JOINT REGIONAL PLANNING PANEL (Sydney West Region)

JRPP No	2014SYW131
DA Number	DA/2014/761/1
Local Government Area	Camden Council
Proposed Development	Construction of a 100 bed residential aged care facility, 12 independent living units and associated site works
Street Address	2-24 Grice Street, Oran Park
Applicant/Owner	Anglicare Diocese of Sydney
Number of Submissions	None
Regional Development Criteria (Schedule 4A of the Act)	Pursuant to the requirements of Schedule 4A of the Environmental Planning and Assessment (EP&A) Act 1979, the proposed development is referred to the Sydney West Joint Regional Planning Panel (JRPP) for consideration and determination as the Development Application has a Capital Investment Value over \$20 million.
List of All Relevant s79C(1)(a) Matters	<ul style="list-style-type: none"> • State Environmental Planning Policy (State and Regional Development) 2011 • State Environmental Planning Policy (Sydney Region Growth Centre) 2006 • State Environmental Planning Policy (Housing for Seniors or People with a Disability) 2004 • State Environmental Planning Policy (Infrastructure) 2007 • State Environmental Planning Policy (Building Sustainability Index: BA

SEPP Variation 1 – Maximum Building Height

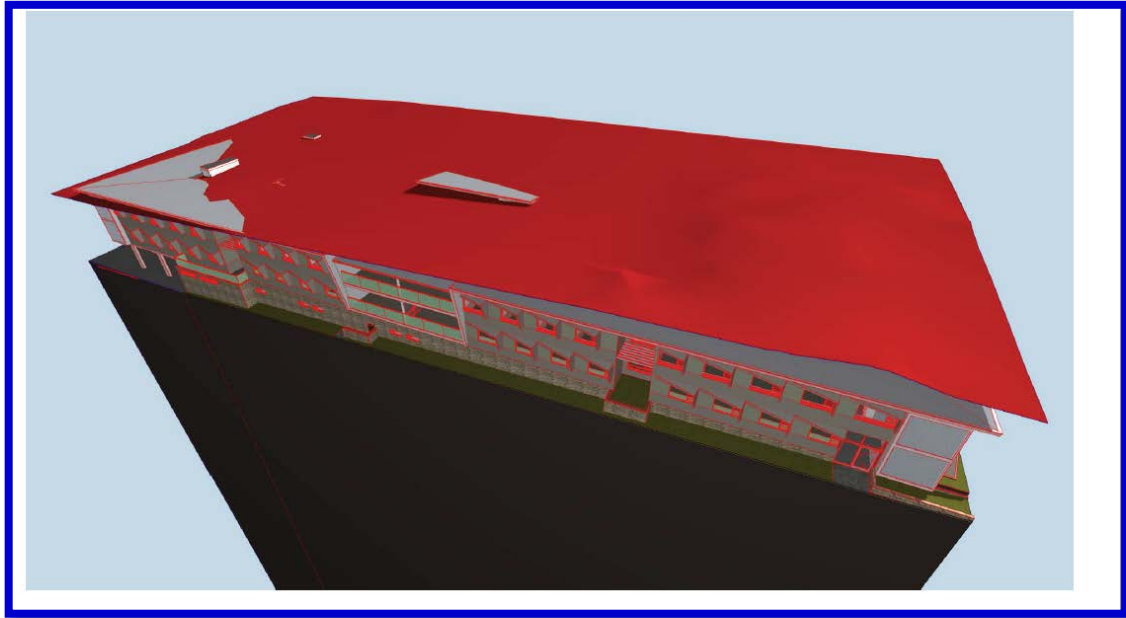
The 9.5m height of building control is exceeded by 790mm in the south-western portion of the RACF and 500mm towards the centre of the RACF. The breach building height is highlighted in grey in the figure below.

Having regard to the objectives of Clause 4.3 “Height of Building”, as they relate to the proposed development and Clause 4.6 “Exceptions to development standards”, it is considered that an adequate level of amenity for the adjoining development is maintained, both on site and surrounding the site. The design ensures buildings and open space continue to receive satisfactory exposure to sunlight and that the two to three storey design of the Residential Care Facility in terms of bulk and scale is consistent with the planning controls.

The building height exceedance will not appear visually dominant in the streetscape and will not detract from views through the area. The building height exceedance does not unreasonably impact on solar access of the adjacent ILU’s and the building is sufficiently articulated to create visual interest and avoids large expanses of blank wall.

It is also noted that the Stage 3 development as approved by the JRPP (DA 371/2010) exceeded the 9.5m height limit by 2.5m. The proposed development reduces this non-compliance to 790mm.

It is therefore considered that the proposed variation sought is justified and that compliance with the development standard is unreasonable and unnecessary in the circumstances of the case. It is recommended that the concurrence of the Director-General of the Department of Planning be assumed for a minor variation to the height of building standard.

DCP Variation 1 – Front Setback

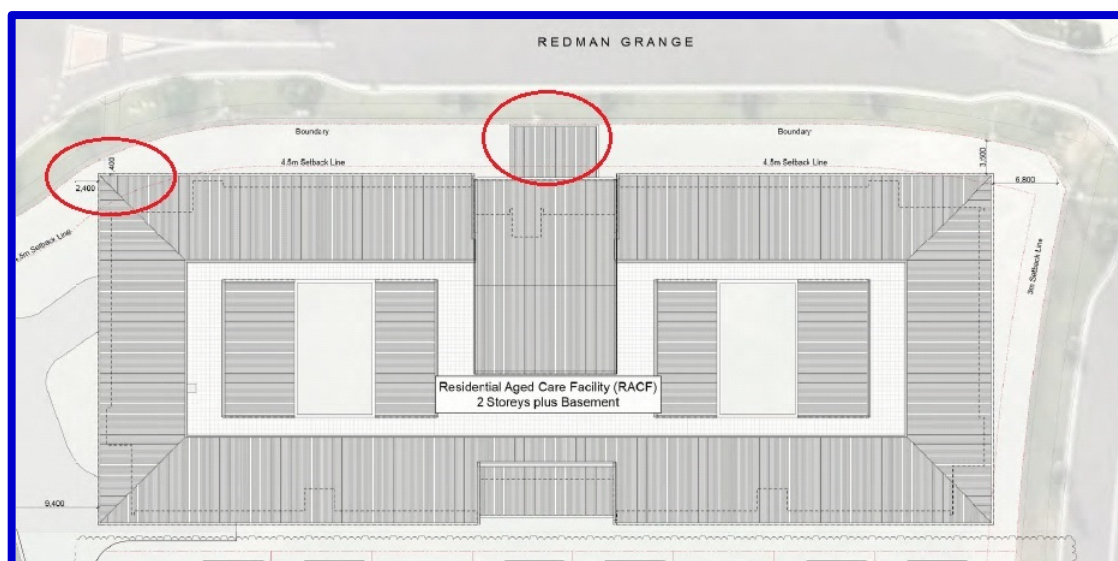
Section 7.7.3 – Multi Dwelling Housing of the Oran Park DCP control plan requires a front setback of 3m to the articulation zone. The proposed development intrudes into the 3m articulation zone as highlighted below in red:

A porte cochere in the middle of the site extends to the front boundary and is non-compliant with the front setback controls. The porte cochere is an architectural feature which will provide a covered entrance large enough for vehicles, (including ambulances), to pass under at the entrance of the building. The addition of the porte cochere is considered appropriate with regard to function of the development.
